PLAN COMMISSION

To: Plan Commission
 From: Dave Kittel Director
 Date: 10/15/2025
 Re: CSM Review – Peters Rd (Laures Subdivision)

To: Plan Commission
From: Dave Kittel, Director of Planning and Community Development
Date: 10/17/2025
Re: site plan review-Lauer Subdivision/Oak Hills Ct

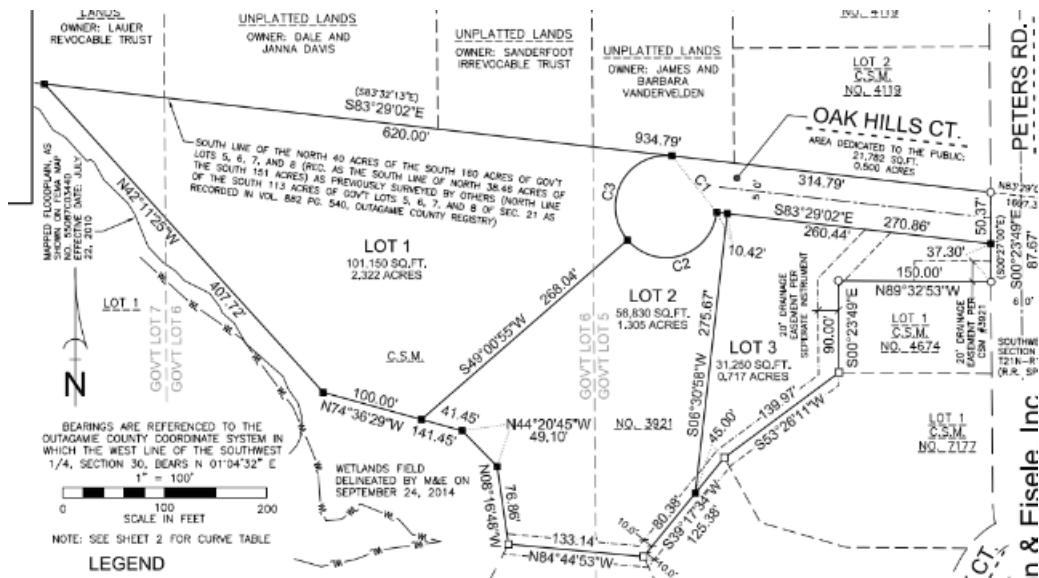
The new access road and cul-du-sac meet municipal requirements per Section 18 and staff is reviewing the plans for the stormwater aspects to this development. It is important to note that frontage is created along the proposed road, and at least one property along a private drive to the north of this development. Something needs to be added to address this in regard to this creating a situation of additional special assessments onto those properties that do not have a benefit from this road. This could be addressed in a few ways but needs to be accounted for before final action is taken on this property.

To recommend approval of this CSM to the Common Council with the following conditions:

- The special assessment issue is addressed with either language added to the CSM, a deed restriction or other form of recorded document for the properties affected by this.
